RENESAS TECHNICAL UPDATE

Product Category	MPU/MCU	Document No.	TN-RX*-A0280A/E	Rev.	1.00
Title	Errata Regarding Setting of the RCR4.RCKSEL Bit for the RX65N Group and RX651 Group MCUs		Information Category	Technical Notification	
Applicable Product	RX65N Group, RX651 Group	Lot No.	Reference Document	RX65N Group, RX651 Group User's Manual: Hardware Rev.2.40 (R01UH0590EJ0240)	
		All

Figure 9.13 Example Flowchart of Initialization when the Sub-Clock is to be Used as the Source to Drive Counting by the Realtime Clock

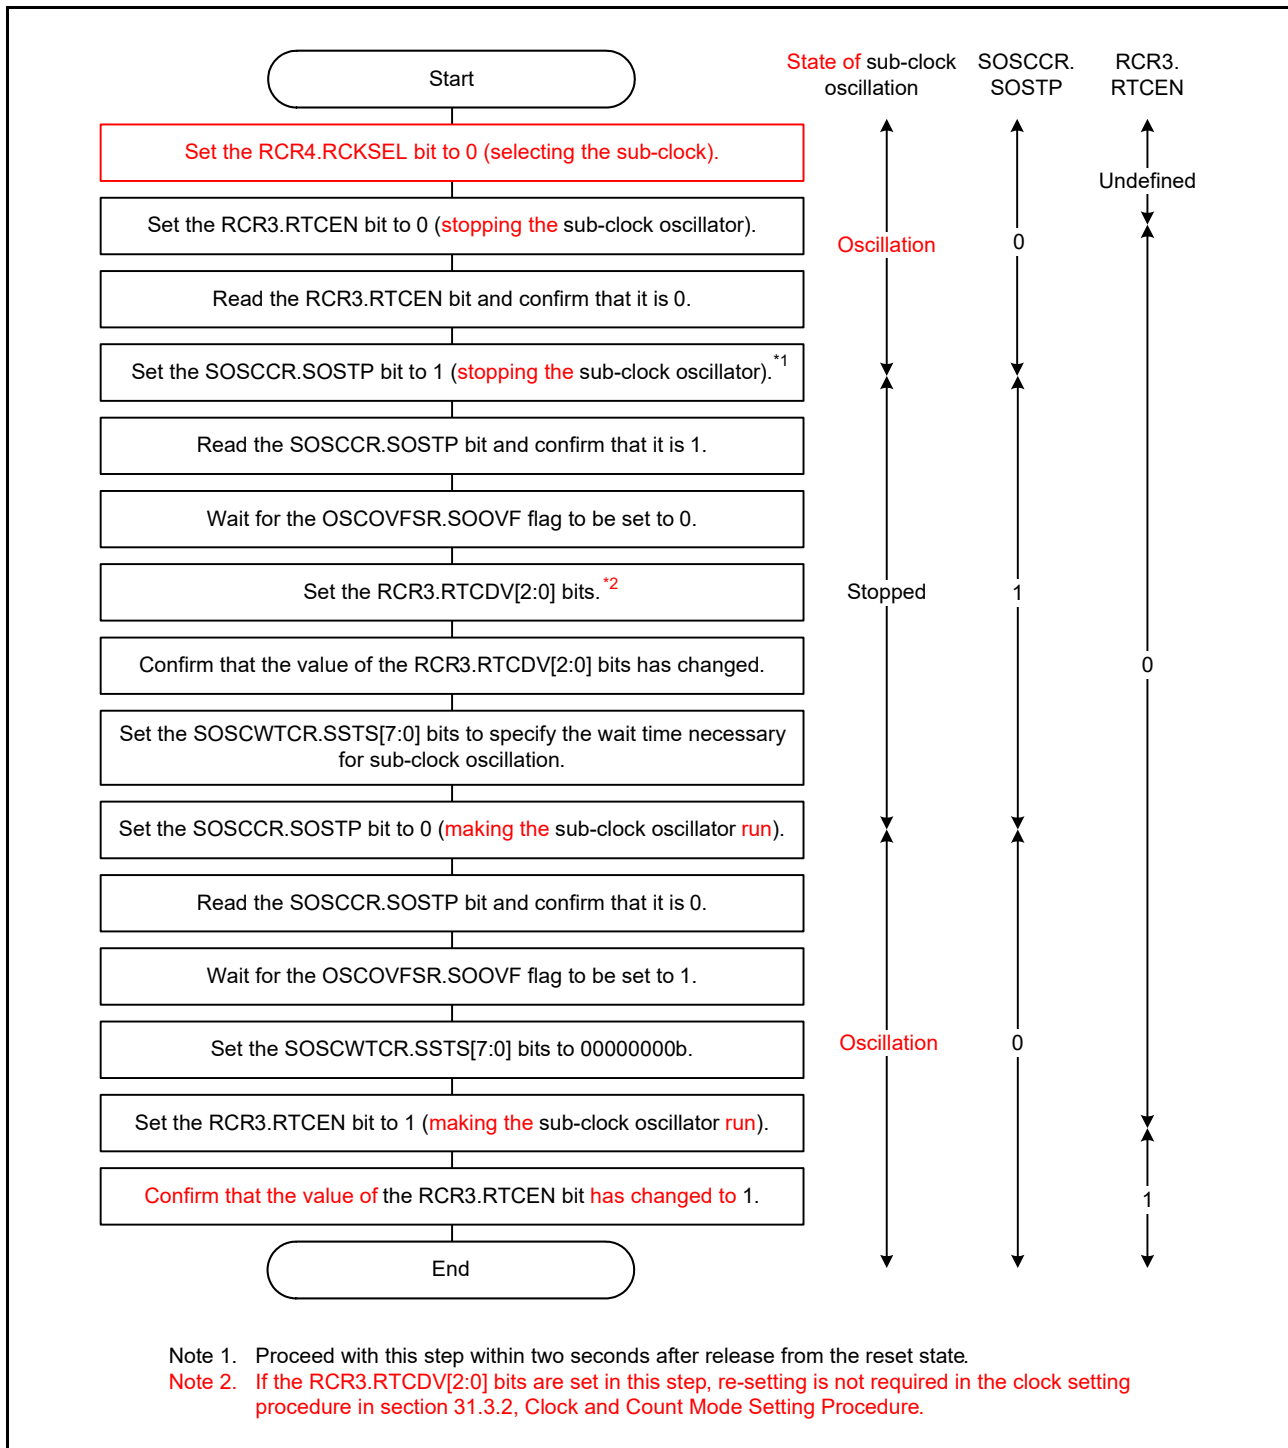
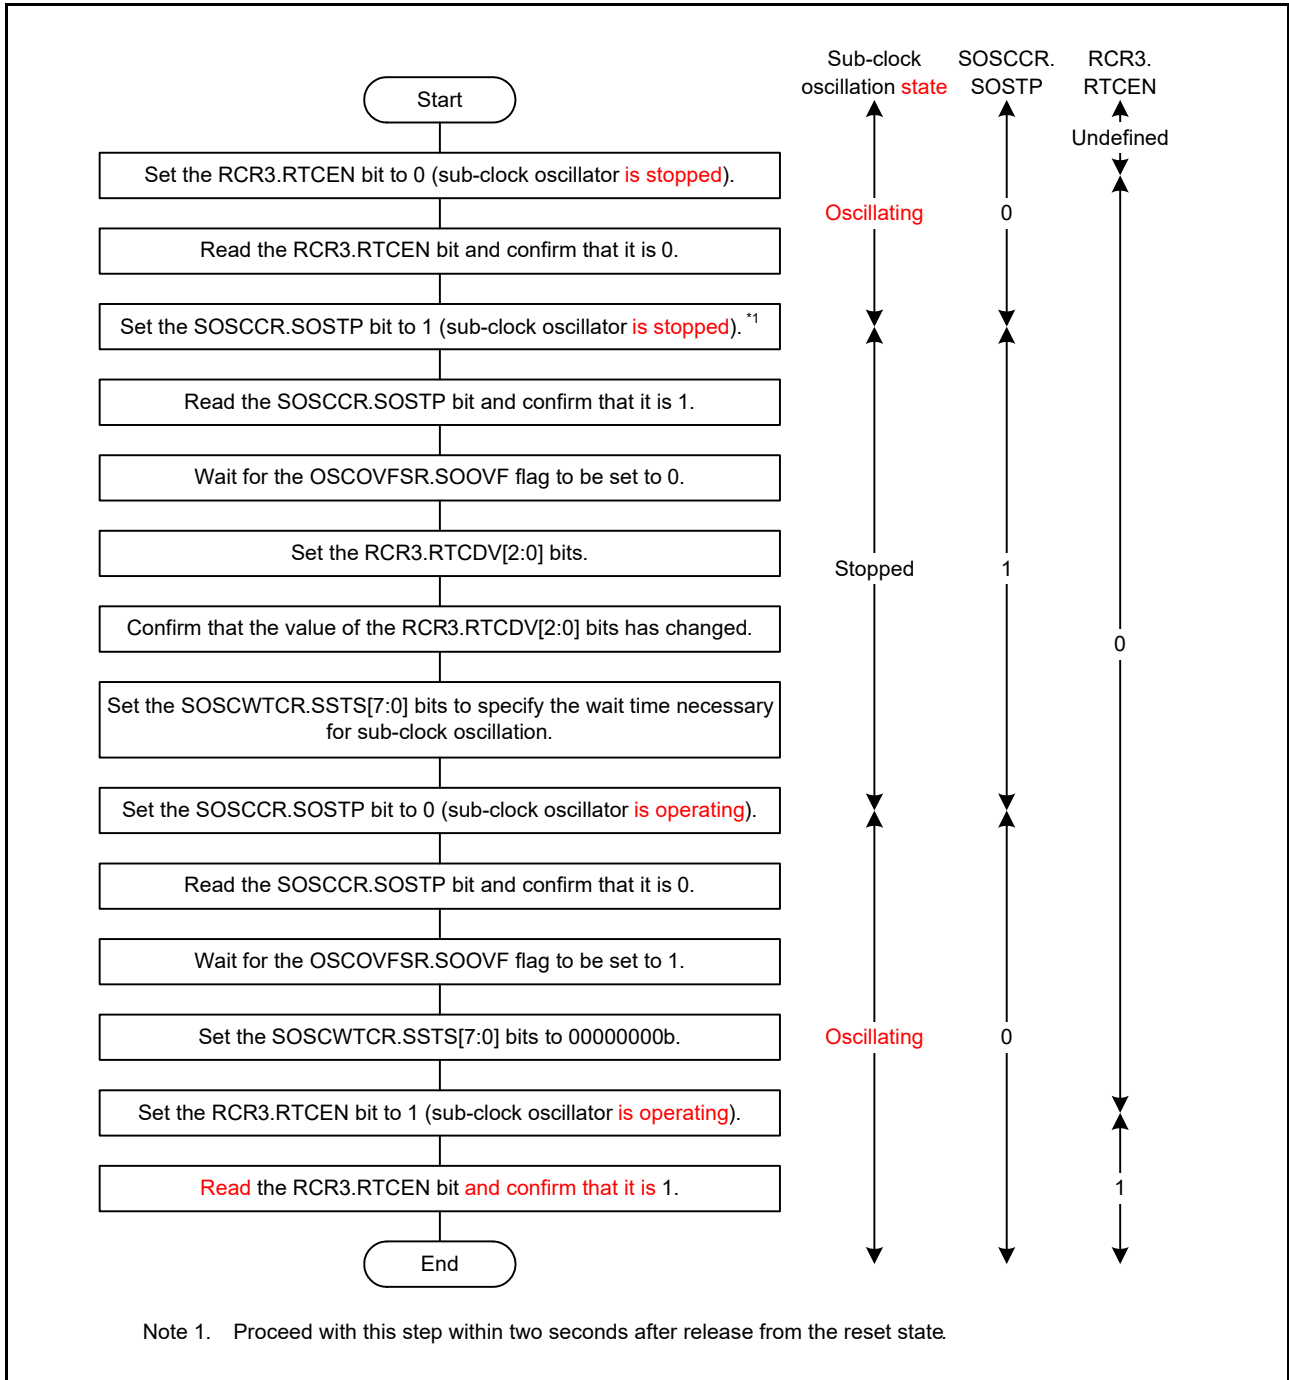
The following deletions are made in Figure 9.13, Example Flowchart of Initialization when the Sub-Clock is to be Used as the Source to Drive Counting by the Realtime Clock.

- The RCR4.RCKSEL bit setting
- Note 2

The title of Figure 9.13 is also modified.

Figure 9.13 Example of Initialization Flowchart When the Sub-Clock Is to Be Used as the Clock Source for the RTC

Figure 9.14 Example Flowchart for Initialization when the Sub-Clock is to be Used only as the System Clock

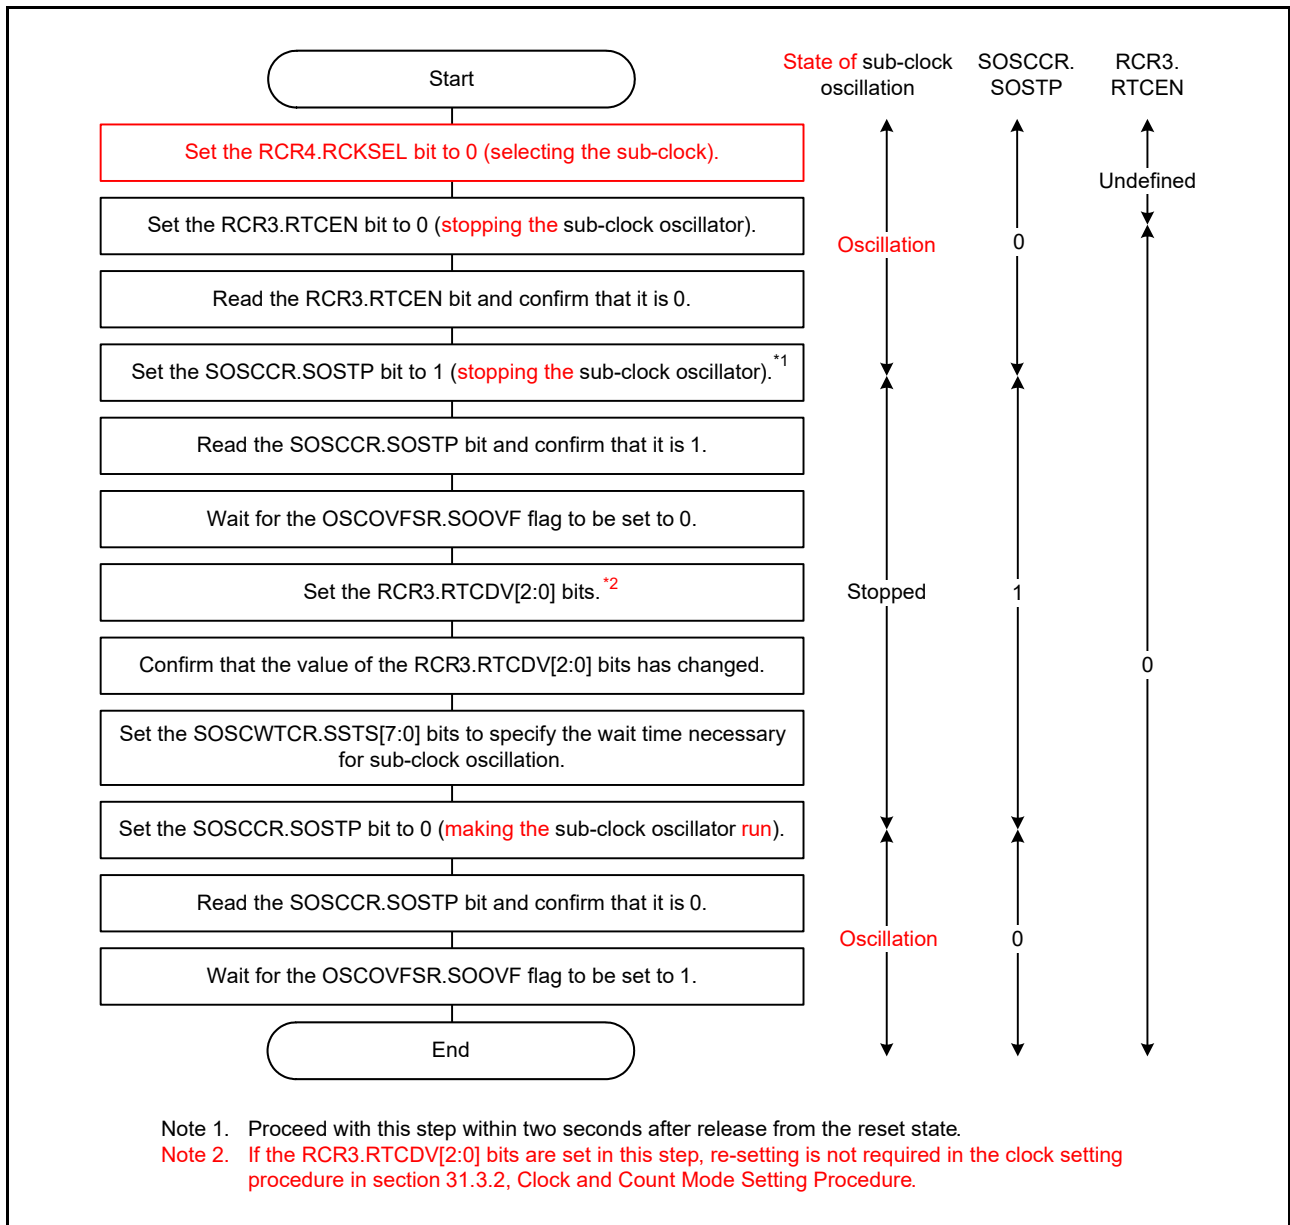
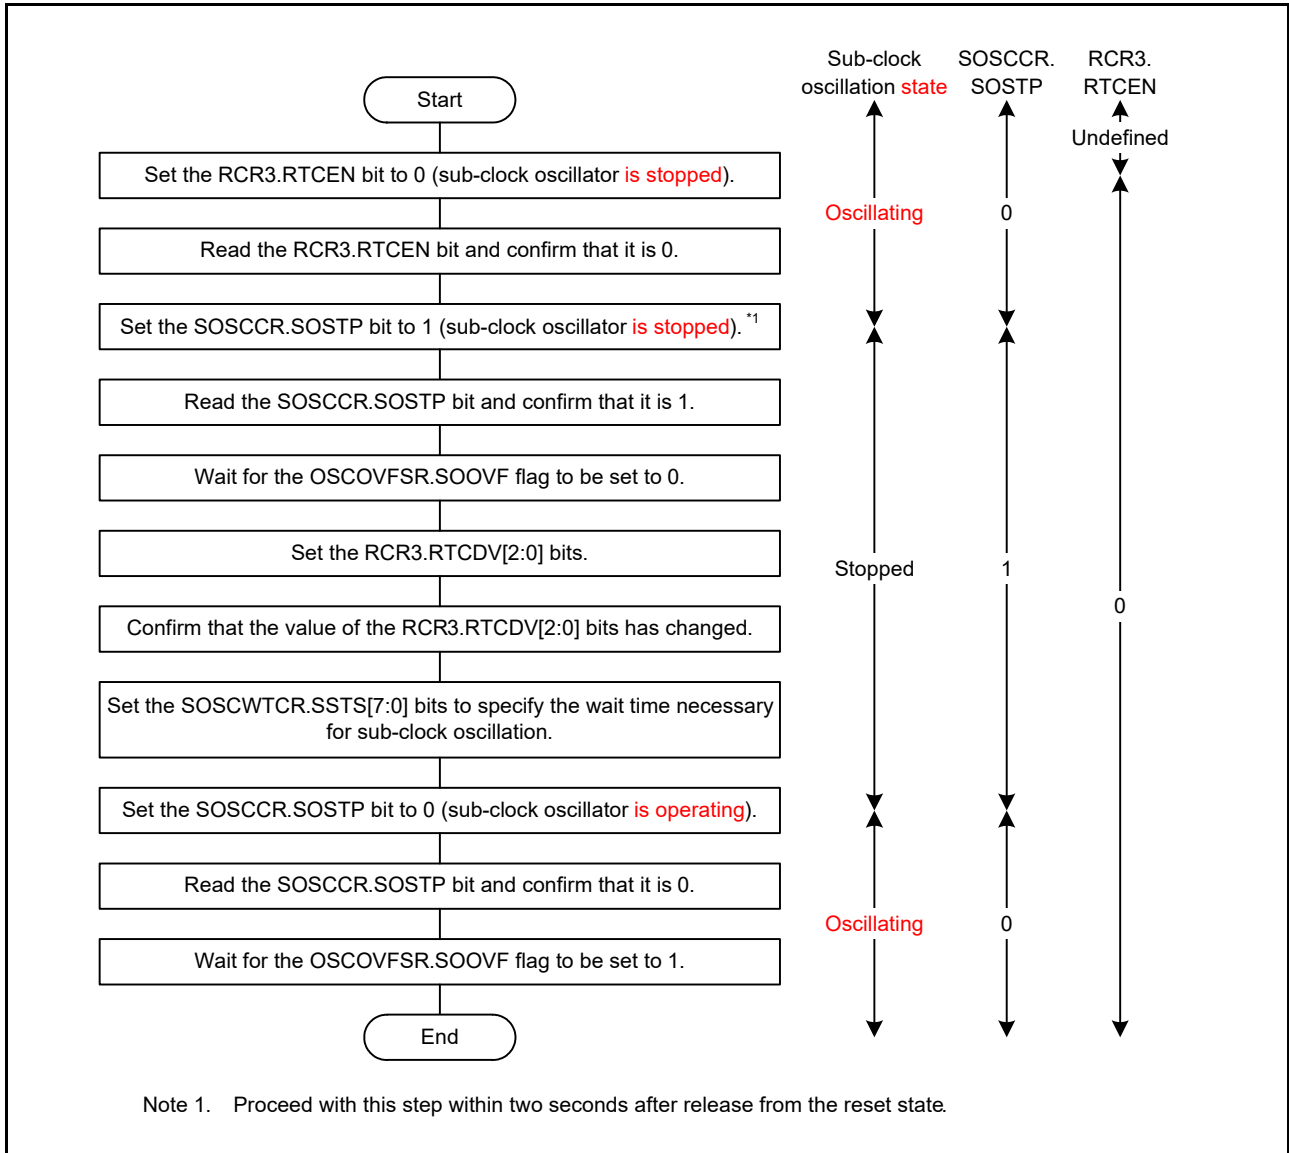
The following deletions are made in Figure 9.14, Example Flowchart for Initialization when the Sub-Clock is to be Used only as the System Clock.

- The RCR4.RCKSEL bit setting
- Note 2

The title of Figure 9.14 is also modified.

Figure 9.14 Example of Initialization Flowchart When the Sub-Clock is Not to Be Used as the Clock Source for the RTC

Figure 9.15 Example Flowchart for when the Sub-Clock is not to be Used

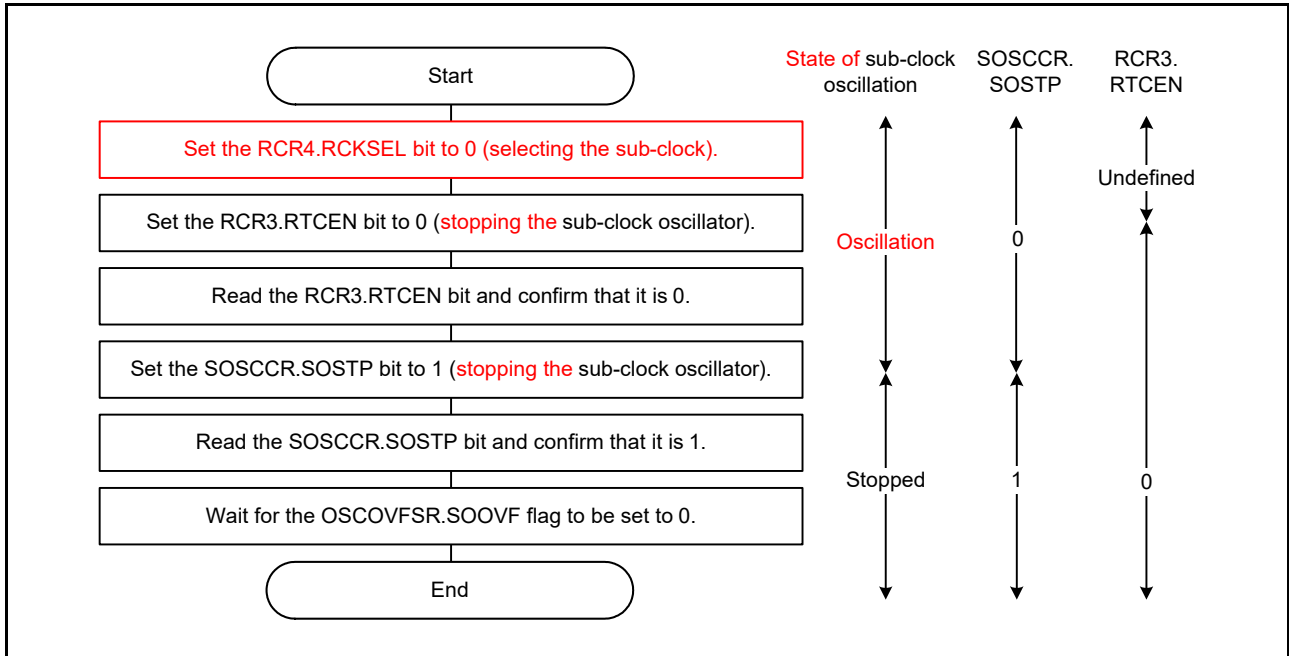
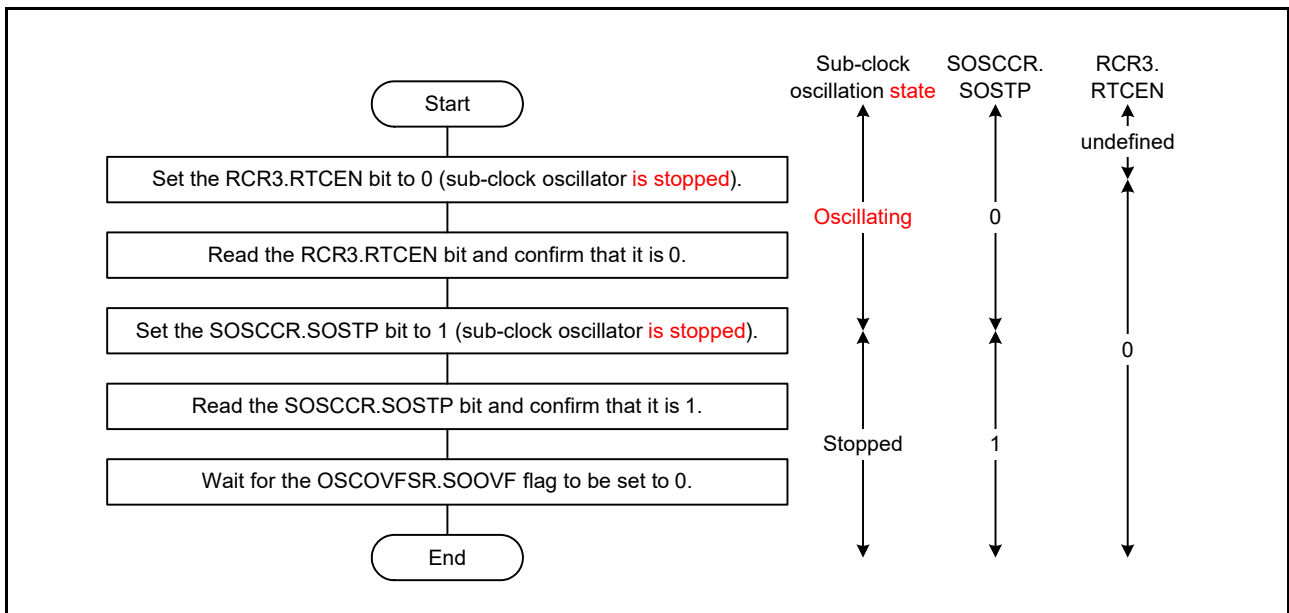
The following deletion is made in Figure 9.15, Example Flowchart for when the Sub-Clock is not to be Used.

- The RCR4.RCKSEL bit setting

Figure 9.15 Example of Initialization Flowchart When the Sub-Clock Is Not to Be Used
